# WINNARD

## DAF LF BRAKE DISC DESIGN UPGRADE

CURRENT C-SPRING DESIGN

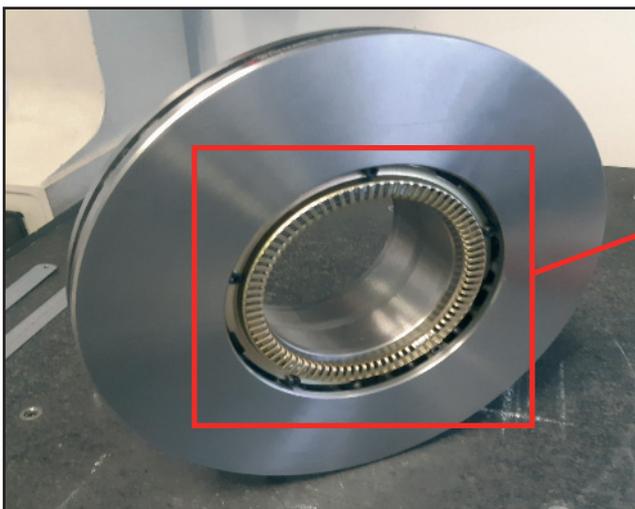
In response to customer feedback we have improved the design of our DAF LF brake disc range. The current design has a steel ABS ring and incorporates a C-spring to hold the ABS ring in place.

In our experience this C-spring is susceptible to movement and corrosion during it's operating life and can cause the ABS ring to work loose.

Our new design is bolted in place ensuring that the ABS ring does not move even after extensive wear and corrosion.

Part numbers being upgraded during 2020: **DA1051 / DA1052 / DA1054 / DA1060**

This new style ABS ring will also be available to purchase separately, new part number ABS0079.
